City of Portland, Maine – Building or Use Permit Application 389 Congress Street, 04101, Tel: (207) 874-8703, FAX: 874-8716

Location of Construction: 91 Hersey St		Owner: Dan J Fuller	Phone: 775-0549 <i>call fr PE/UP</i>	Permit No: 970420
Owner Address: 91 Hersey St- Ptld ME 04103		Lessee/Buyer's Name:	Phone:	<div style="border: 2px solid black; padding: 5px; text-align: center;"> PERMIT ISSUED MAY - 7 1997 CITY OF PORTLAND </div>
Contractor Name: Dan Doyle		Address:		
Past Use: 1-fam w deck/porch	Proposed Use: 1-fam w encl porch	COST OF WORK: \$ 10,500	PERMIT FEE: \$ 75	Zone: <i>R-3</i> CBL: 128-C-007 Zoning Approval: <i>OK S/S/S/S</i> Special Zone or Reviews: <input type="checkbox"/> Shoreland <input type="checkbox"/> Wetland <input type="checkbox"/> Flood Zone <input type="checkbox"/> Subdivision <input type="checkbox"/> Site Plan maj <input type="checkbox"/> minor <input type="checkbox"/> mm <input type="checkbox"/>
Proposed Project Description: (increase by 4 ft- match deck) enclose porch - include deck - 00C00C000000C00C0C		FIRE DEPT. <input type="checkbox"/> Approved <input type="checkbox"/> Denied	INSPECTION: Use Group: <i>BOC96</i> Type: Signature: <i>[Signature]</i>

DAT

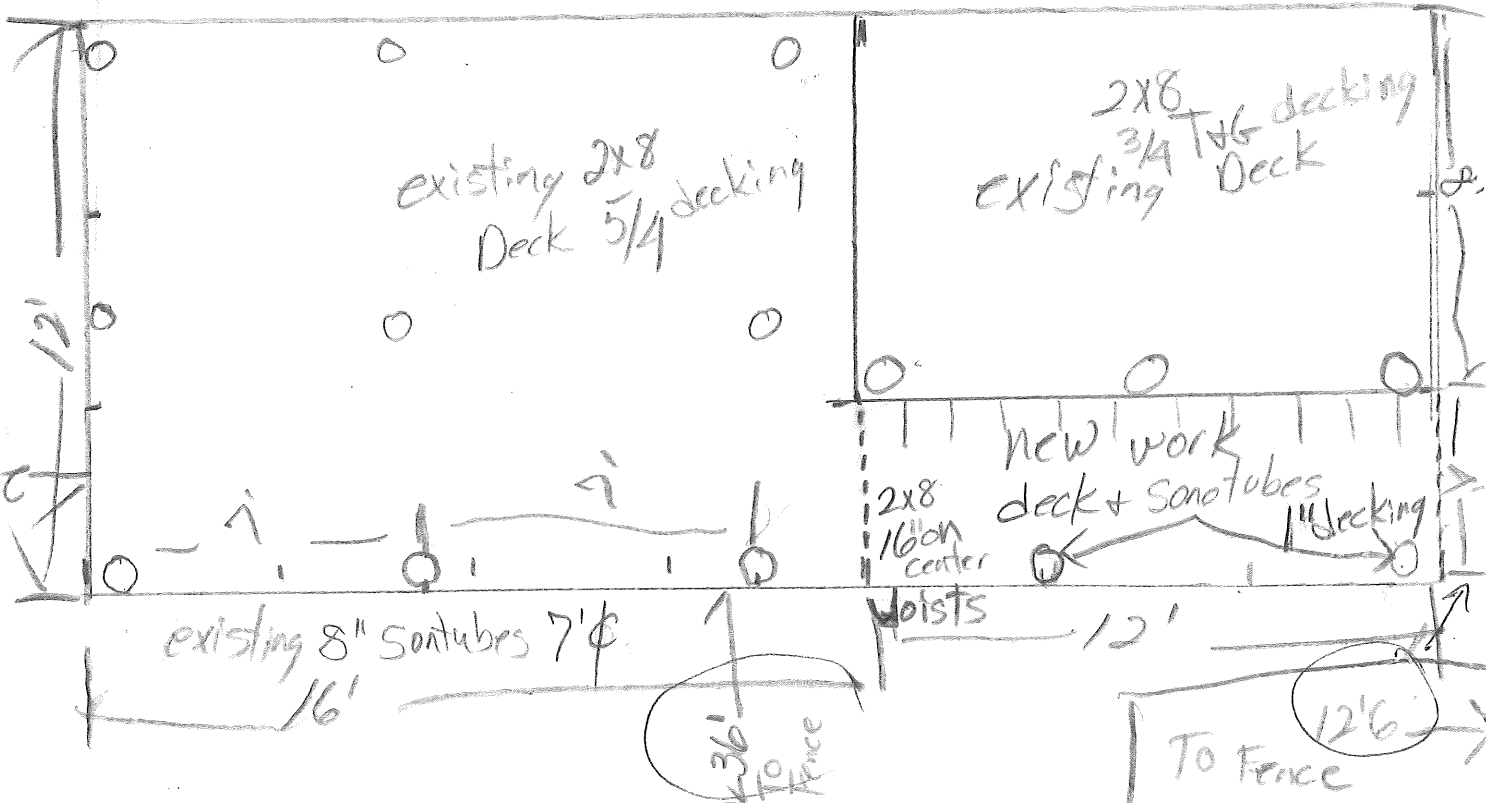
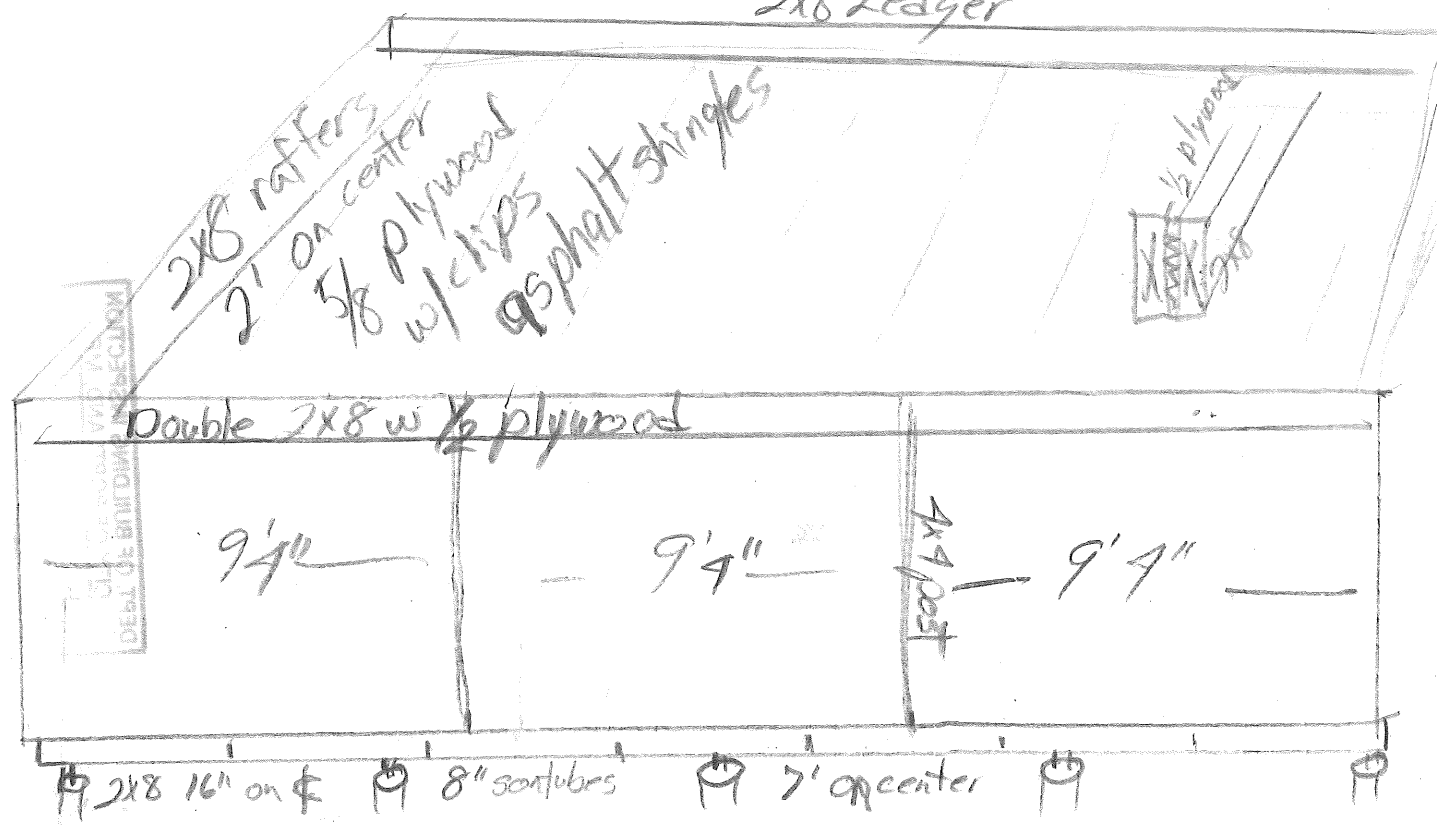
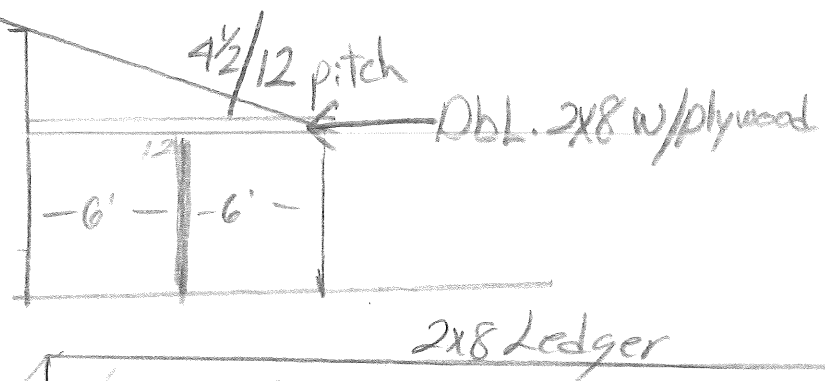
The existing porch with extend only to the width of the existing deck.

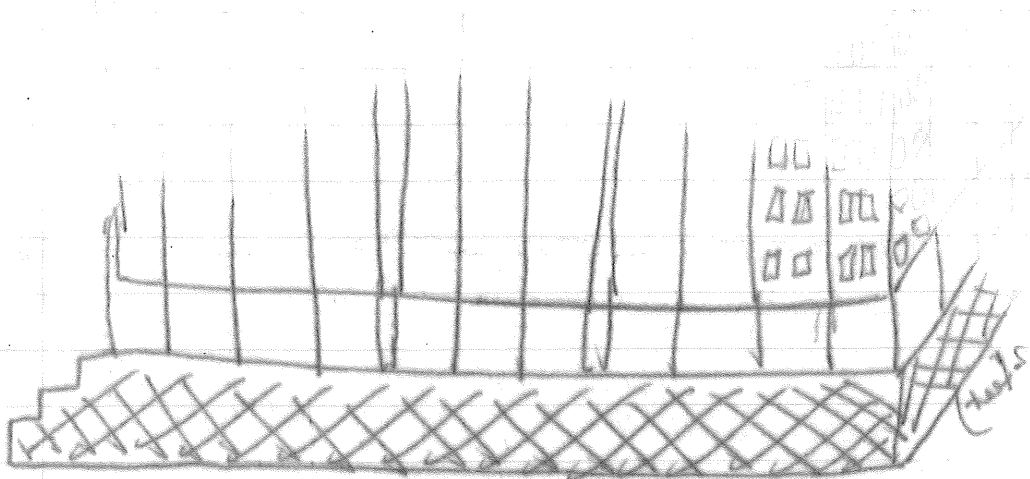
- What's
- How is roof supported - what is pitch
- what is construction of the roof
x what's it made of. Spru
- Plot Plan (proposed area of coverage with additional area of porch)
